**VIRGINIA ELECTRIC AND POWER COMPANY (DOMINION)
NORTH ANNA POWER STATION UNITS 1 AND 2
REQUEST FOR ADDITIONAL INFORMATION REGARDING
REALISTIC LARGE BREAK LOSS OF COOLANT ACCIDENT (RLBLOCA)
ANALYSIS RESULTS FOR THE PROPOSED TECHNICAL SPECIFICATIONS
CHANGES AND EXEMPTION REQUEST FOR USE OF FRAMATOME ANP
ADVANCED MARK-BW FUEL**

Realistic Large Break LOCA Analysis Results – North Anna

Dominion Responses to NRC Request for Additional Information
North Anna Realistic LBLOCA Analysis

Figure 7.2-33: NAPS Unit 2 Containment and Loop Pressures for the Limiting Break

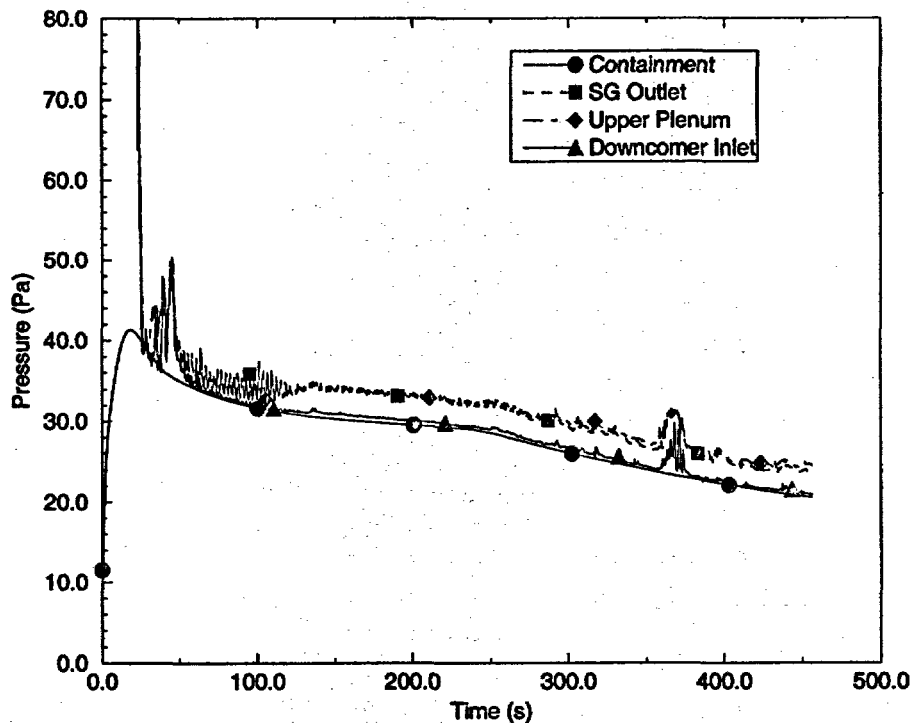
- Q11. Downcomer Boiling - The containment pressure in Figure 7.2-33 indicates that the containment pressure is at about 30 psia and continues to decline at 200 seconds into the limiting LBLOCA. Figures 7.2-23, 7.2-30, and 7.2-32 seem to indicate that downcomer boiling occurs at about 375 seconds into the transient. The containment plot ends at 200 seconds and it appears from Figures 7.2-23 and 7.2-32 that the calculation was terminated at ~460 seconds. At ~460 seconds, the PCT drops to ~450°F. At this time, the (extrapolated) containment pressure is 30 psia or less. The saturation temperature at 30 psia is ~250°F or less, but the drop in PCT stops at ~450°F. 10 CFR 50.46 requires that analyses to be run until the core is quenched.

a. Extend the analysis results tables and graphs, particularly Table 7.2-11 and Figure 7.2-33, to beyond the time that stable and sustained quench is established.

By the conclusion of the limiting North Anna Units 1 and 2 LBLOCA calculations, the event has gone through all the phenomenological characteristics of a LBLOCA. The calculation is terminated by an analysis guideline rule that was established for identifying core quench following PCT. Part of that logic tests for when the maximum clad temperature of the hot rod drops below 500°F. That temperature, 500°F, bounds the T_{min} point (note, T_{min} is also a statistically treated parameter in the FANP RLBLOCA methodology). Once heat transfer has crossed from film boiling to

transition boiling, rod temperatures will rapidly cool to saturation. No changes in ECCS delivery and no new phenomena are expected; hence, there is no reason to believe that the calculation has not run its course.

For the limiting RLBLOCA Unit 2 transient (the event times are reported in Table 7.2-11), the core quench/calculation termination time is 457 seconds. Figure 7.2-33 is re-plotted below on an extended time scale.
